Work Order ID 161685

D3290-041 REPLACEMENT WINDOW ASSEMBLY

DRAWING NO. D3290	TITLE REPLACEMENT WINDOW ASSEMBLY	REV. C	DART AEROSPACE LTD ENGINEERING ORDER		D.E.O. NO. D3290-C-1	SHEET NO. SHEET 1 OF 1	SCALE NTS
DRAWN <i>qp</i>	CHECKED <i>h</i>	MFG. APPR. <i>E</i>	APPROVED <i>W</i>		DE APPR. <i>#</i>		
DATE 09.09.18	DATE 09.09.18	DATE 09.09.18	DATE 09/09/21		DATE 09/09/21

D3290-1 FRAME

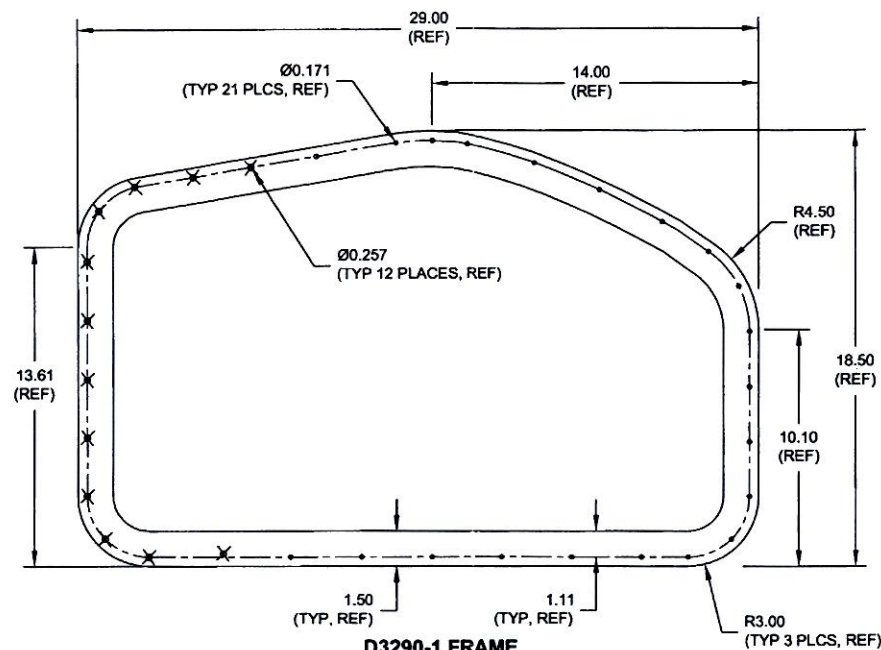
CHANGE MATERIAL THICKNESS OF D3290-1 FRAME TO 0.063 FROM 0.040. REF PAR 09-033.

MATERIAL CALL-OUT OF D3290-1 FRAME ON SHEET 1 IS AMENDED AS FOLLOWS:

- 1) MATERIAL: 6061-T6 (OR 6061-T62) ALUMINUM SHEET ~~0.040 THICK~~ 0.063 THICK (REPLACE)
 PER AMS-QQ-A-250/11 OR AMS 4025 OR AMS 4027
~~(REF. DART SPEC. M6061T6S.040)~~ REF. DART SPEC. M6061T6S.063 (REPLACE)
 OR
 5052-H32 ALUMINUM SHEET ~~0.040 THICK~~ 0.063 THICK (REPLACE)
 PER AMS-QQ-A-250/8 OR AMS 4016
~~(REF. DART SPEC. M5052H32S.040)~~ REF. DART SPEC. M5052H32S.063 (REPLACE)
